ADVISORY GROUP & COMMUNITY FEEDBACK

REVISED VISION PLAN AND DESIGN GUIDELINES

PROPOSED HEIGHTS FOR FANNON STREET/ROUTE 1 PARCEL

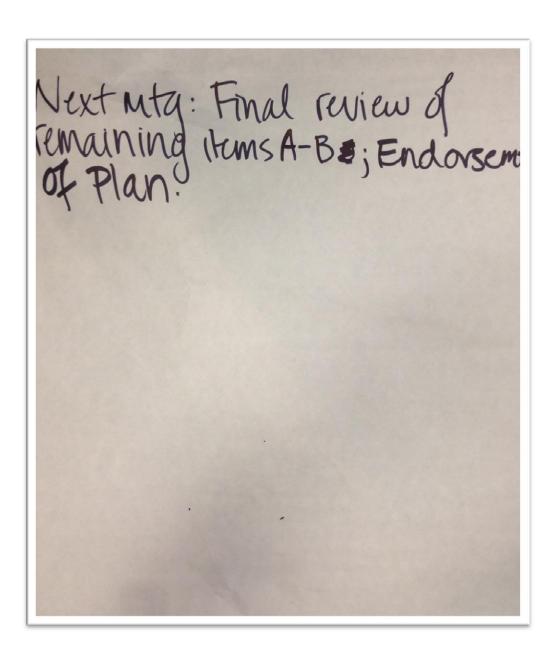
Han comments p14 - concern re shared pkg-nd to be a stronger statement of participal (hight been done well to date). (1.20) p15-10 maker space uses. p16 - group homes-allow + incentrivize p20 - update chart re pedx + RT park. 237- clanfication on public+ private in R.O.W. (lack of Consistency throughout doe).
A) Struts + sidewalks are all to be dedicated as public. = Add text about streets + sidewallis R.O.

P61-bikeshare location check Stewart/MJPark-correct. 768 5.11-15' may be too Much -Concern about transition whenadjacent to Home etc. (Reviselang.) 285 5.106 - light shielded to avoid spellover to park. P84-add publicart.
universal design-notinonology p85 - 26 the stds. Exconsist. W/Infill. P99 7.26-add LED, signs 7.28-allow signs to be on late

P99 7.16- clarify to include all confirm way finding is Included. 7.31 "high intensity lights such as" and LED General-High Qual. Materials-+ LEED-part of DSUP - Lighting - downidirected - avoid Spillover Appendix - anticipated # of ses.
